# **Central Planning Authority**

**Agenda** for a meeting of the Central Planning Authority to be held on **March 15, 2023 at 10:00am in Conference Room 1038, 1st Floor, Government Administration Building, and Elgin Avenue.**

**CPA/06/23**

## **List of Applications Presented at CPA/06/23**

Figure 1: DOE's 2013 habitat map extract showing the application site outlined in red.

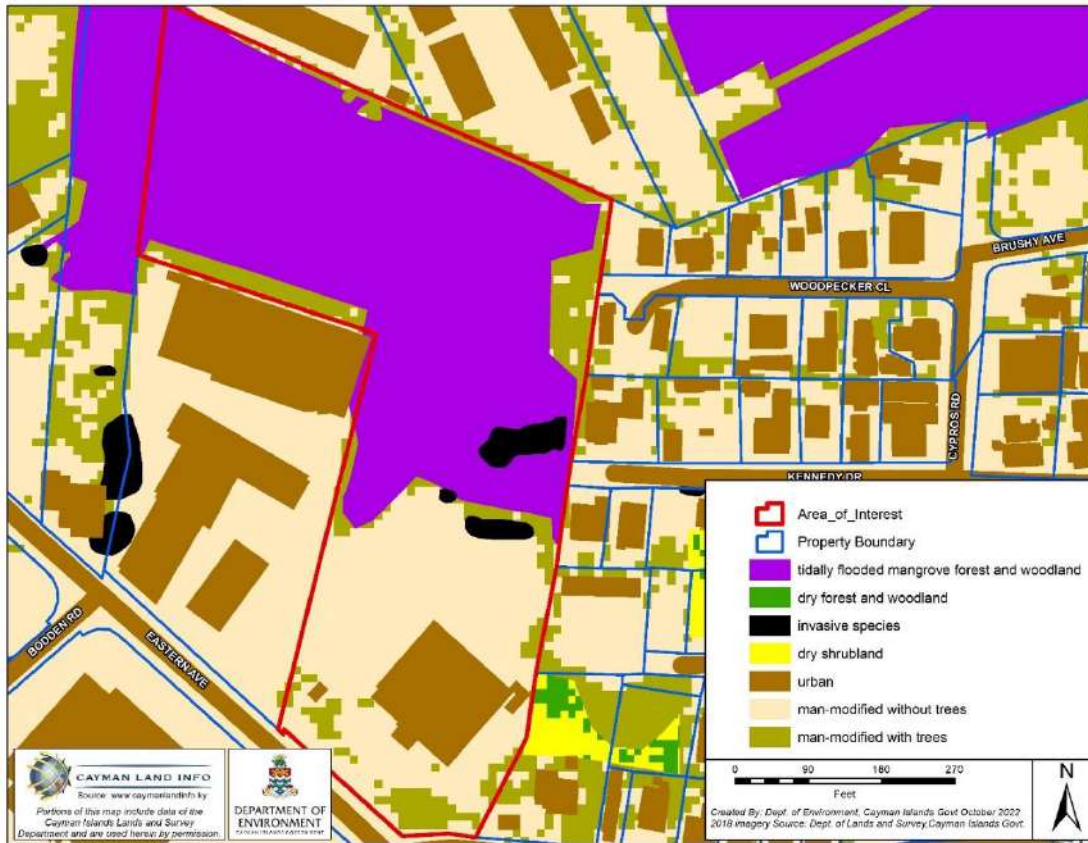
*The northern part of the subject parcel consists of primary habitat classified as tidally flooded mangrove forest and woodland, as shown in Figures 1 and 2.*

**Mangroves are protected under Schedule 1, Part 2 of the National Conservation Act (2013). It is an offence to remove mangroves unless permission is explicitly sought to remove them either through planning permission or a National Conservation Council Section 20 permit.**

***As mangroves are protected under the National Conservation Act (2013), all mangrove vegetation shall be retained in accordance with the National Conservation Council's Species Conservation Plan for Mangroves (2020).***

- 1) All mangrove vegetation shall be retained in accordance with the National Conservation Council's Species Conservation Plan for Mangroves (2020).*
- 2) There shall be no land clearing, excavation, filling or development of the resultant subdivided parcels without planning permission for such works being granted.*

*Figure 1. The habitat at the site shows man-modified areas, dry shrubland areas, and sparsely vegetated rock areas.*

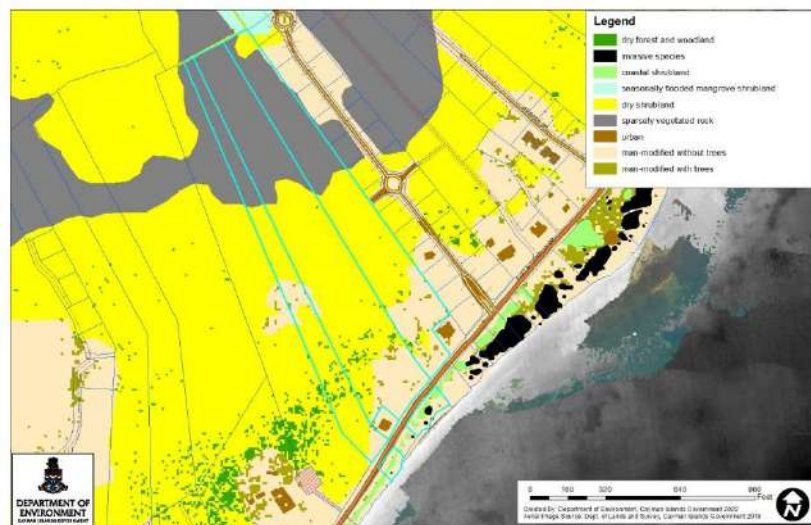
*The site consists of sparsely vegetated rock in the northern part, primary dry shrubland habitat in the central part and man-modified in the southern part (see Figure 1). Primary habitat is mature habitat in its natural state, otherwise uninfluenced by human activity where ecological processes are not significantly disturbed. These habitats are often very old, existing long before humans and may consist of many endemic and ecologically important species. Primary habitat is in severe decline and becoming a scarce and highly threatened resource as a result of land conversion for human activities.*

*The site was nominated by a member of the public for protection in the 2022 round of Protected Area Nominations. It was nominated because it has a unique geology and landscape that could position it as 'Hell East'. The unique landscape could easily accommodate a viewing point that would complement the other nature and history-based attractions in the area. The site is relatively close to the National Trust for the Cayman Islands' East End Lighthouse which, for example, is a stop for guided bike tours in East End. The site could form one more component in attracting local and tourist pressure and value from the western half of Grand Cayman.*

- The southern part of the site, where it is man-modified, could be developed with an Old Age Home and higher-density housing (e.g. serviced townhouses or assisted living or accessible apartments) in order to help meet housing needs with greater land-use efficiency.*
- The central part of the site, which hosts dry shrubland, could be retained in a natural or semi-natural state with walking paths or seating areas. This would benefit the people living in the development and within the wider area as they would have outdoor space and potentially traffic-free areas for amenities.*
- The northern part of the site, which is sparsely vegetated rock, could incorporate a viewing platform and interpretative signage to become a Crown-owned tourism attraction.*
